ECU list - Motortech

Customer ECU list for MIC, VariStep, Logger, Uninox

SW version 1.8.0

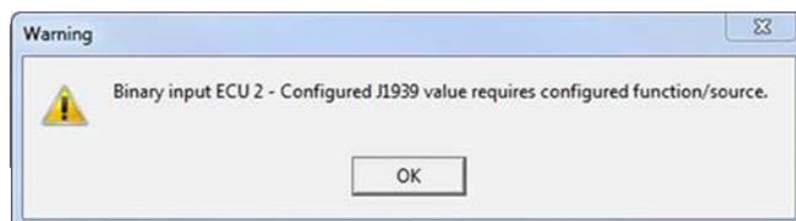
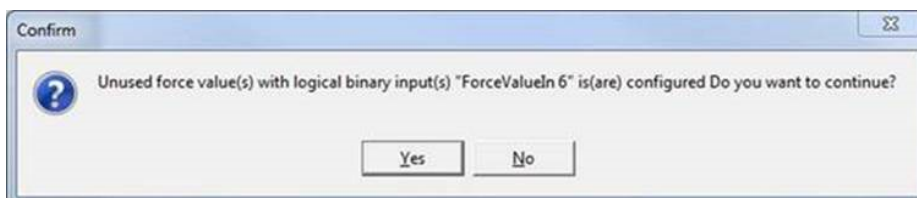
- ▶ Change the period of timeout
 - The timeout of the message has been improved. (PGN 0xFE6, source address 0x00, period increased from 500ms to 1000ms)

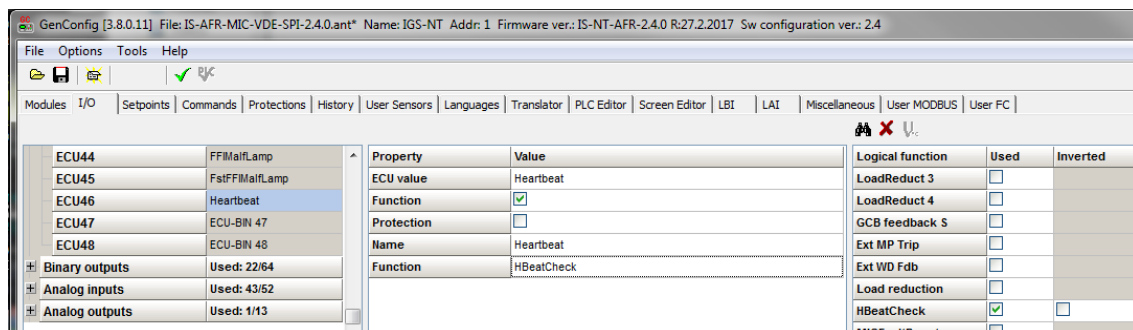
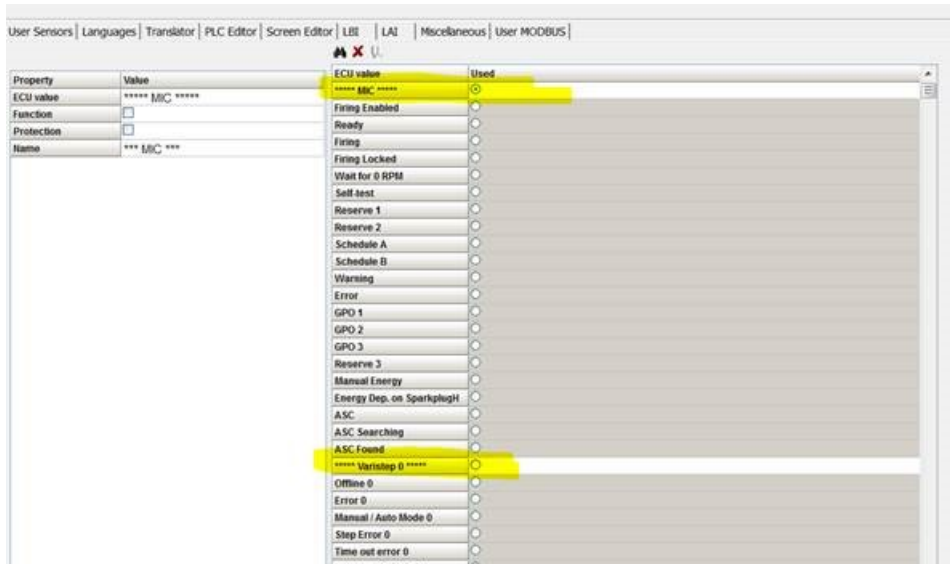
- ▶ MIC address and frame change
 - Conflict frames after merging MIC and Logger support.
 - Change source address of frames read from MIC to 0x34 (52).
- ▶ Heartbeat
 - In order to enable heartbeat control of communication between ID-mobile Logger and IS-NT, there are two new binaries.
 - "Heartbeat" Binary output in Logger eng
 - "Heartbeat" Binary input in MIC+2Varistep+Logger
 - Dataloger heartbeat check – There is BIN from Dataloger in ECU values called Heartbeat. This BIN is automatically configured as input to new HBeatChek function. Output from this function is new LBO HBeatError, this LBO is activated when Heartbeat signal from dataloger is not cycling or cycling slowly. If needed Shutdown can be activated based on this signal. Warning is issued automatically when Heartbeat signal from dataloger is not cycling or cycling slowly.

- ▶ Protocol support of MIC changed from AIO to J1939 Motortech
 - Particular changes has been made to support J1939 Motortech protocol according to MIC3/MIC4/MIC5 J1939 Motortech documentation ver. 0.9.
- ▶ Logger engine support
 - Engine data logger
 - Support of Logger-EngJ1939 cloned from ECU list - Mobile 6.0.0 and added into ECU list - Motortech.
 - This unit is meant to be configured in DriveConfig.
 - Support of Logger-EngJ1939 modified in the way that all the values are configurable in DriveConfig.
- ▶ Visual separator for multi module ECU support
 - Visual separator divide particular groups of analog and binary inputs and outputs of ECU. These separators has no logical function. They serve as visual hint for GenConfig or DriveConfig user.
